<b>DOCKETED</b>	
<b>Docket Number:</b>	24-OPT-03
<b>Project Title:</b>	Soda Mountain Solar
<b>TN #:</b>	268378
<b>Document Title:</b>	Errata
<b>Description:</b>	Errata to the Soda Mountain Solar Project Staff Assessment
<b>Filer:</b>	Lisa Worrall
<b>Organization:</b>	California Energy Commission
<b>Submitter Role:</b>	Commission Staff
<b>Submission Date:</b>	1/30/2026 3:07:55 PM
<b>Docketed Date:</b>	1/30/2026

## ERRATA

On December 29, 2025, the California Energy Commission (CEC) staff docketed a Staff Assessment, including a draft environmental impact report (EIR), for the Soda Mountain Solar Project (24-OPT-03; TN 268059).

**Figure 5.2-3 Potential Jurisdictional Aquatic Resources within the Project Area**

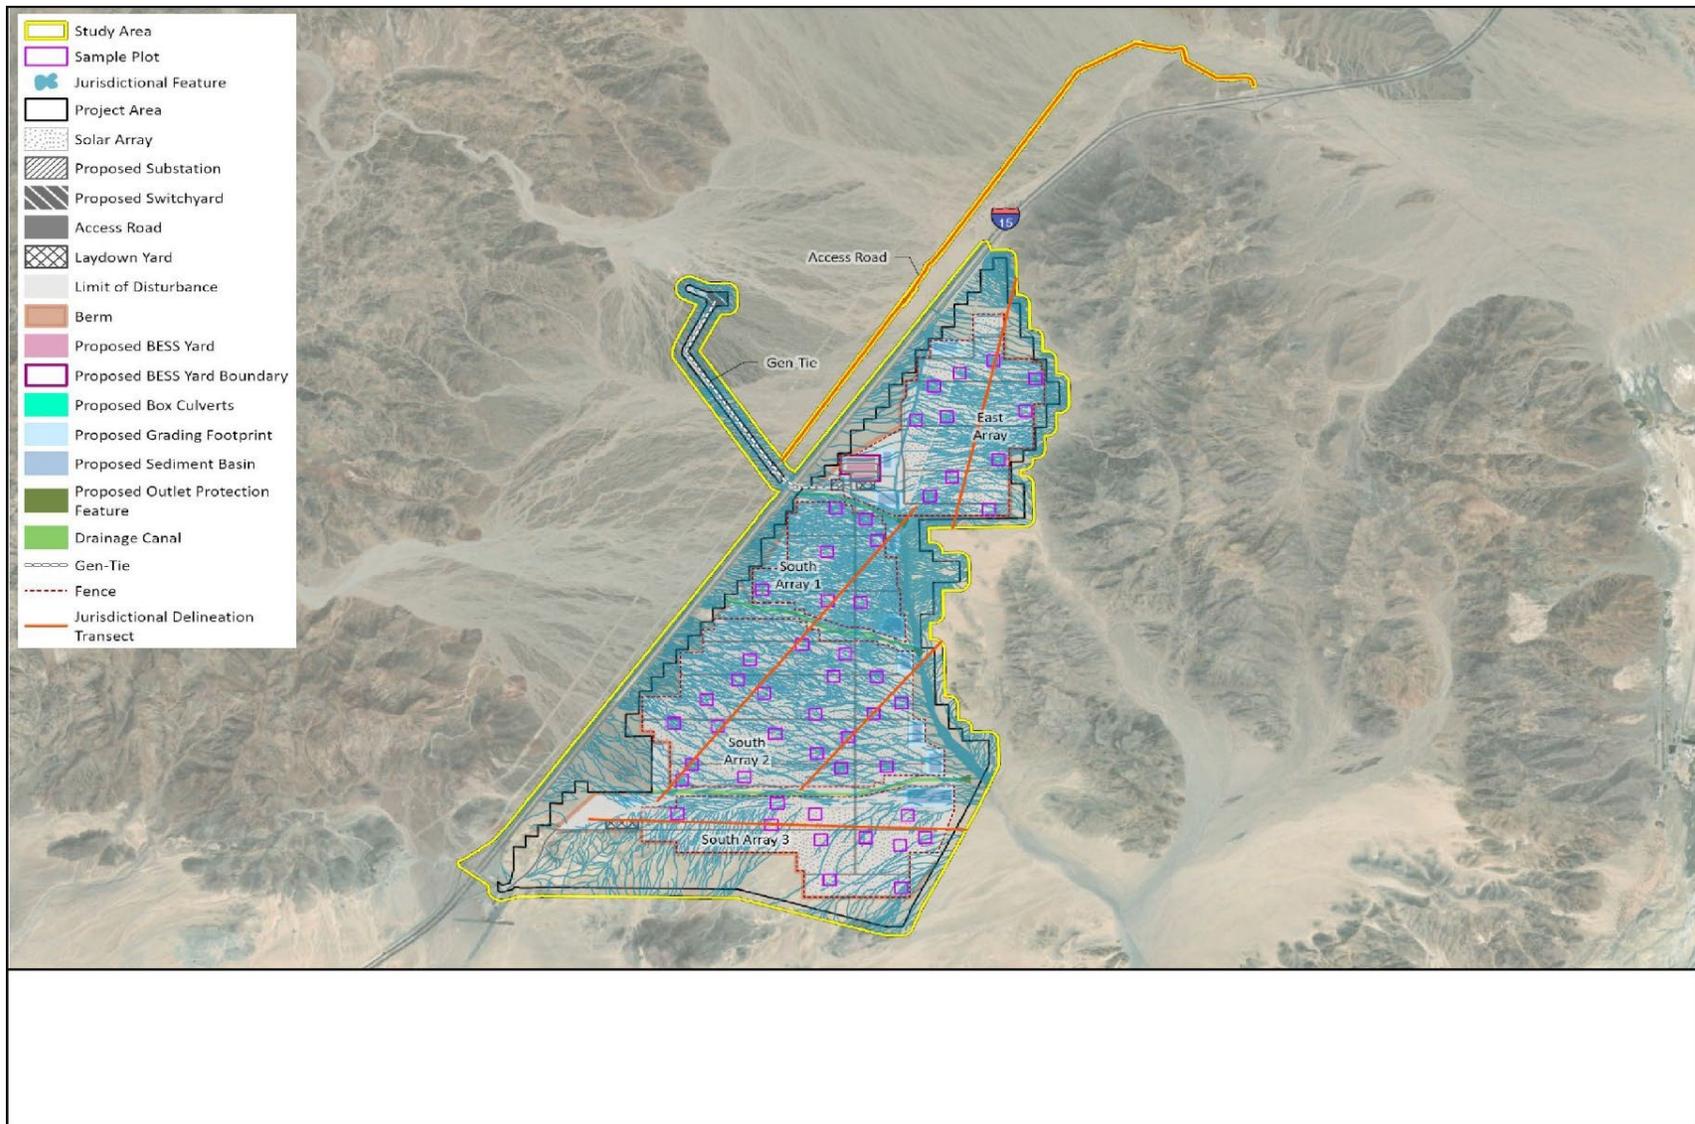
Construction of the project would not likely to affect habitat used by the Mojave fringetoe lizards, which is located south of Array 3. However, it could affect sandy areas east of Array 3 if storm flows are inadvertently diverted around the project (see **Figure 5.2-~~73-2~~**).
